GE Energy

MFN 06-135

Docket No. 52-010

**Subject: Partial Response to RAI Letter Numbers 20 and 27 Related to ESBWR Design Certification Application – Seismic Design – DCD Sections 2.5 and 3.7 – RAI Numbers 2.5-2 through 2.5-7; 3.7-1 through 3.7-4, 3.7-6, 3.7-9, 3.7-10, 3.7-13 through 3.7-15, 3.7-17 through 3.7-23, 3.7-28, 3.7-31, 3.7-36, 3.7-40 through 3.7-49, 3.7-51, 3.7-53, and 3.7-56**

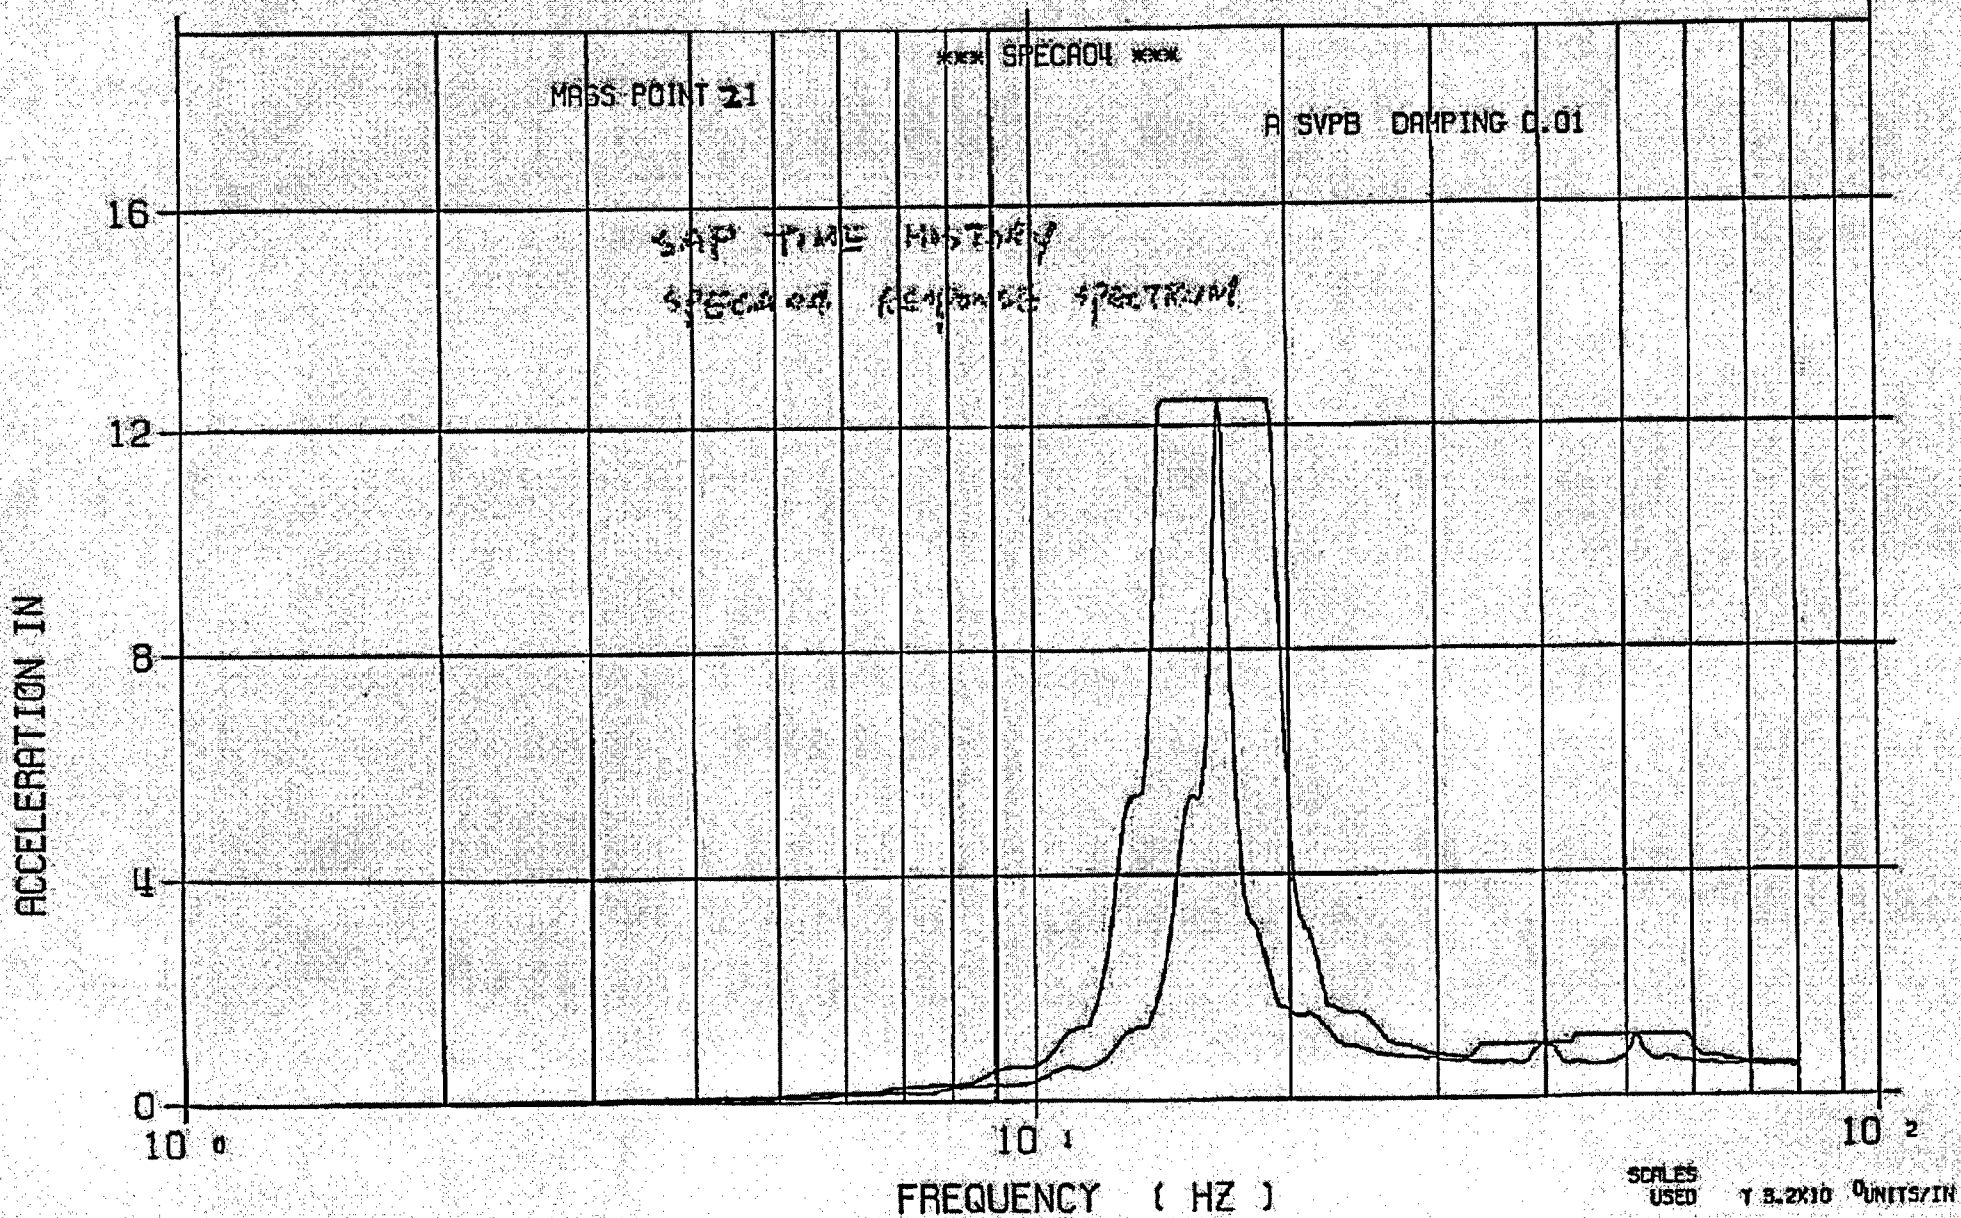
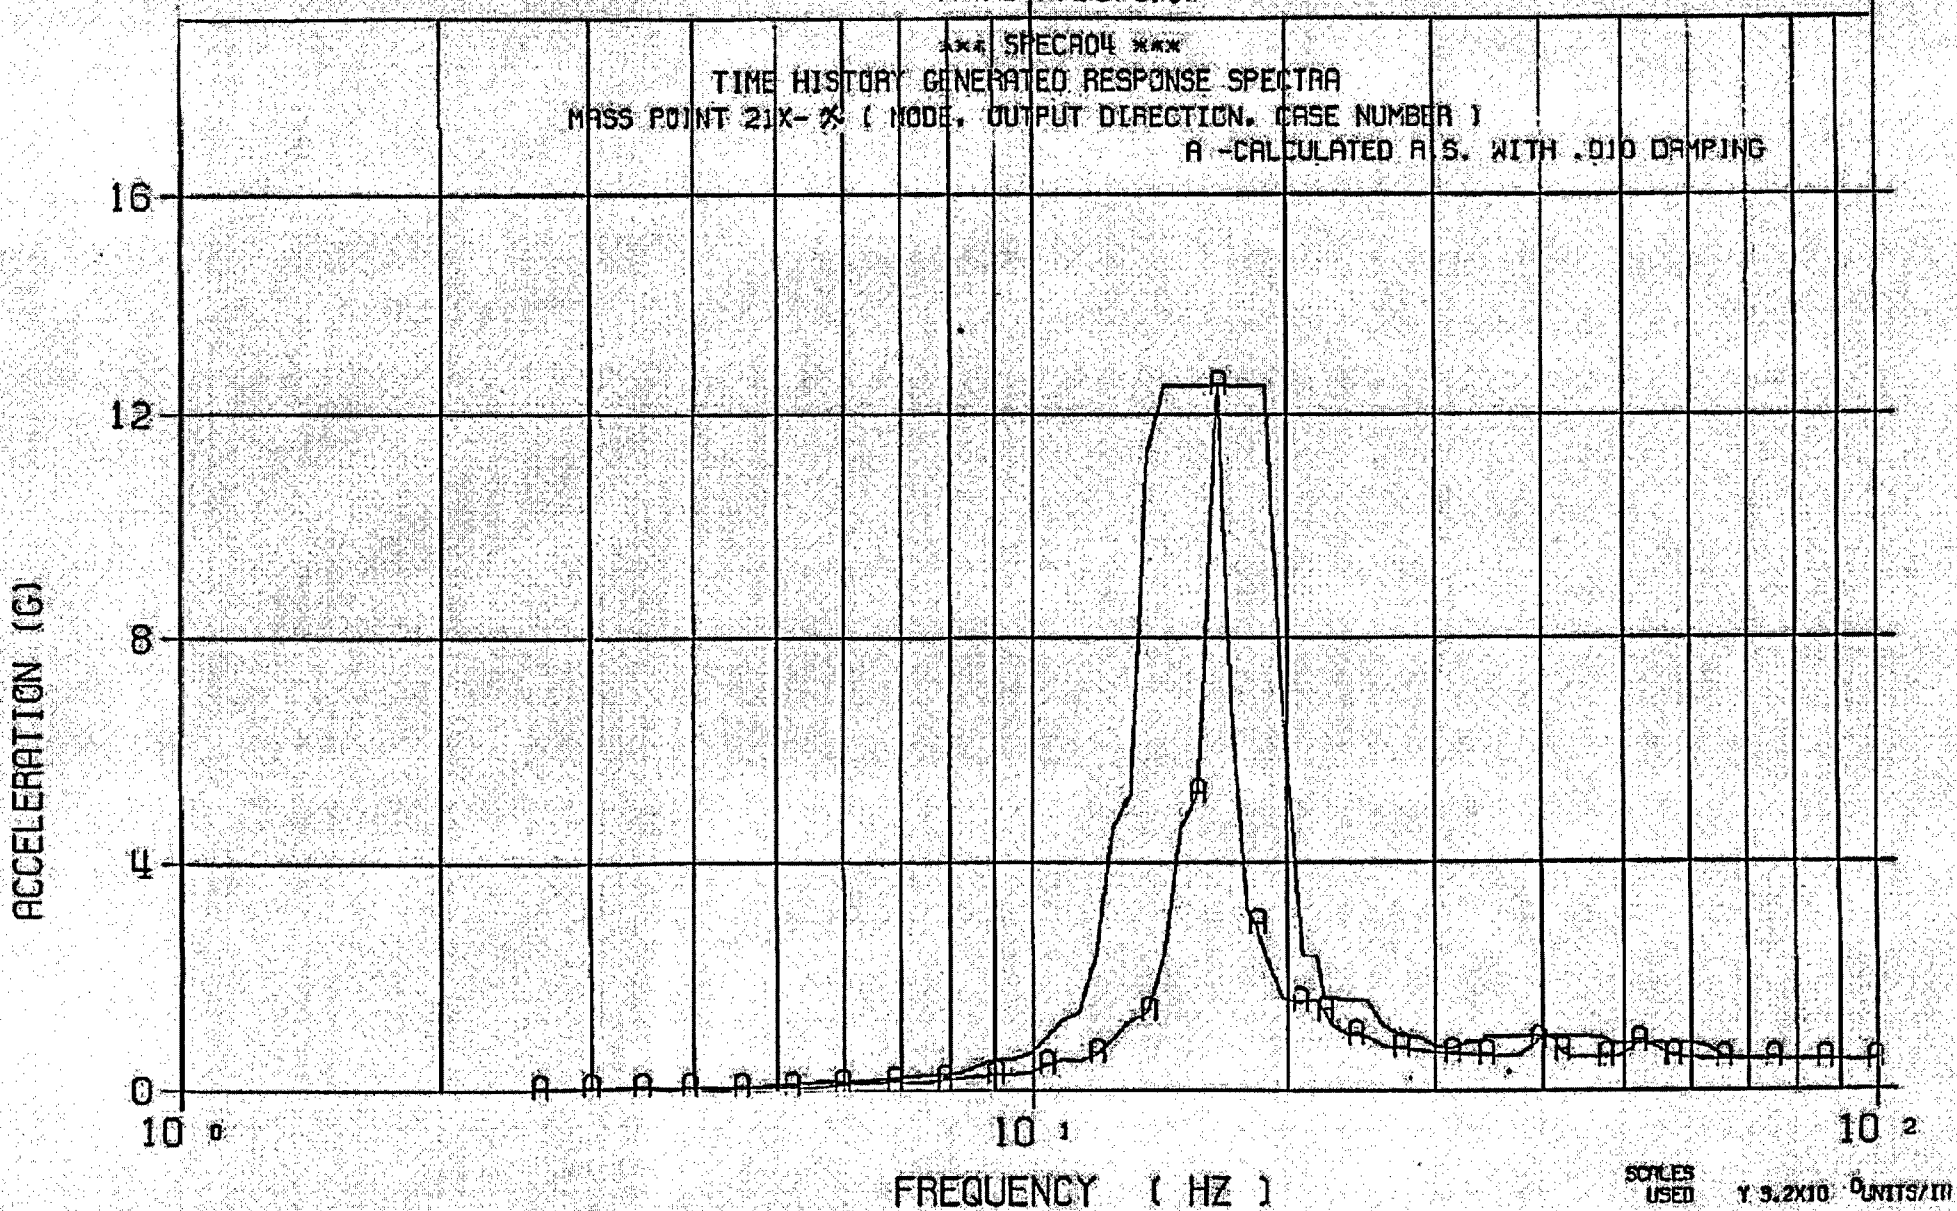
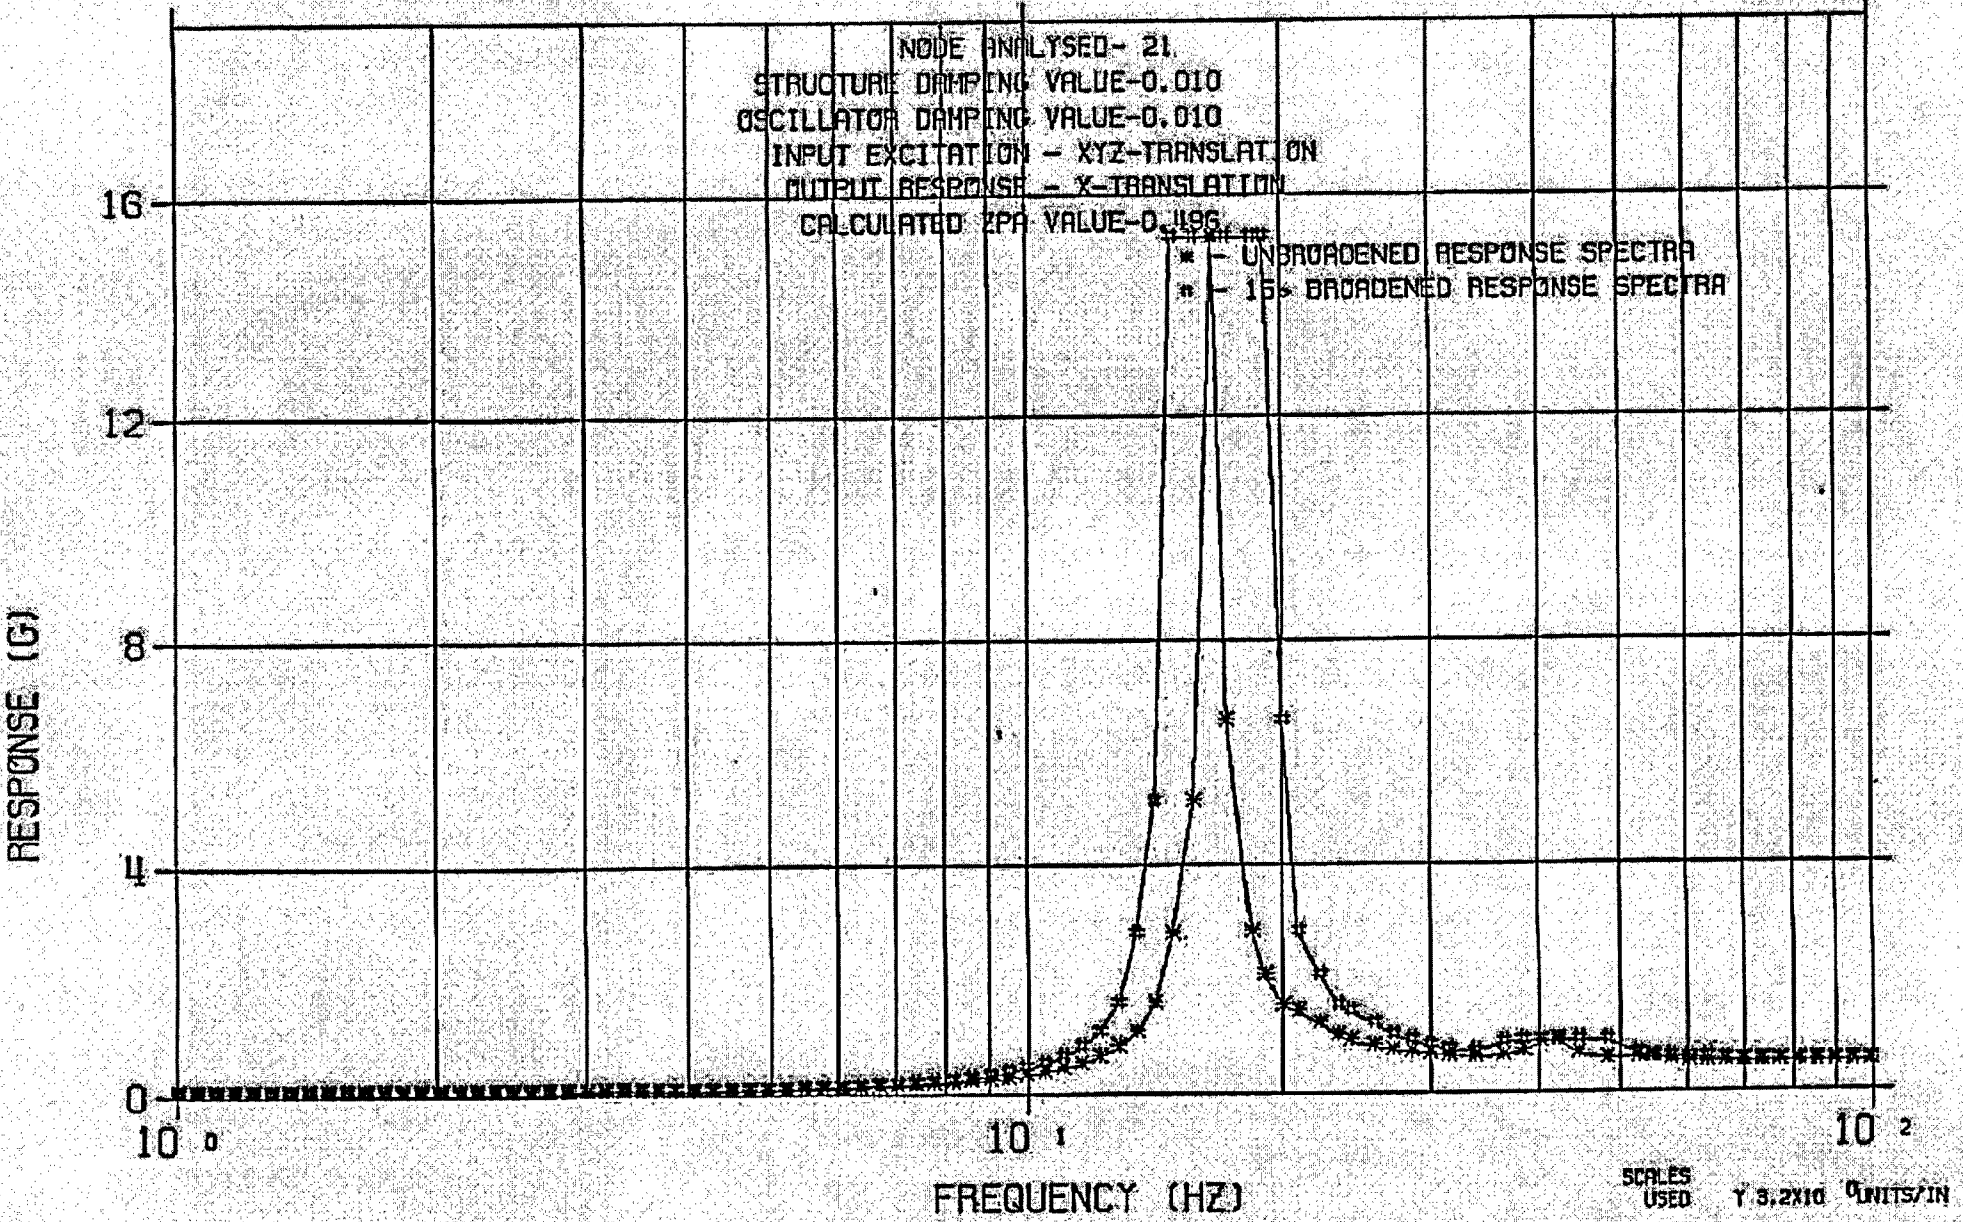
*DCD Appendix 3D (3D.4.6.1) identifies the ERSIN Computer Program, which provides direct generation of local or global acceleration response spectra. Its stated use is to generate response spectra for pipe-mounted and floor-mounted equipment. To facilitate the staff's evaluation of this computer code, the applicant is requested to submit a validation package for the specific types of ESBWR applications, including comparisons to response spectra generated by time history analysis.*

Numerical results, including response spectrum plots, of the comparative analyses considered in the verification of the ERSIN computer code are provided in the attachment.

The plots presented show clearly that the ERSIN03 time history results are only slightly different from the SAP4G07 time history results in all directions. Further the ERSIN03 Response Spectra results are conservative to the time history results in all frequency ranges.

The ERSIN program effectively calculates an accurate time history and only slightly conservative response spectra values for SRV load case.
